## FORT BEND COUNTY ENGINEERING

RE: Del Webb Boulevard Traffic Control

Del Webb Boulevard at Persimmon Grove

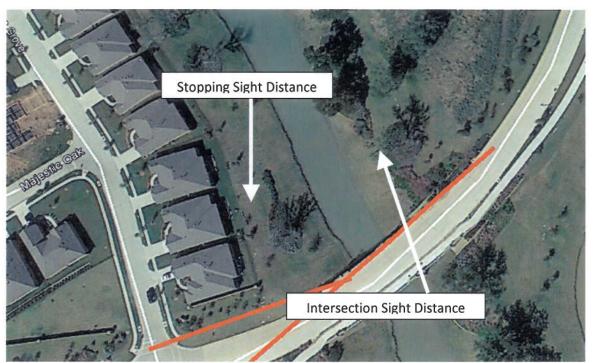
Based on the sight distance analysis, intersection sight distance is not provided for either approach on Persimmon Grove at Del Webb due to the bridge rail. Stopping sight distance is not provided for the southbound approach. At the recreation center driveway, intersection sight distance is not provided for the westbound approach but stopping sight distance is provided. The sight distance obstruction is caused by the earthen berm supporting the parking lot that is several feet above the roadway. There were no sight distance restrictions at the intersection with River Fern Drive.

The underlying cause of the sight distance restrictions are that the design engineers did not account for all physical obstructions and the overall curvature of the roadways. Without the curved roadways, these obstructions probably would not have created sight distance restrictions to the extent observed. These obstructions could have been addressed during design and construction to eliminate the sight distance restrictions.

The Fort Bend County Engineering Department recommends all-way stop control at the intersections of Del Webb Boulevard at Persimmon Grove and Del Webb Boulevard at the recreation center driveway. If Del Webb Boulevard is reconstructed in the future, efforts should be made to redesign the roadway and adjacent areas to eliminate the sight distance restrictions.
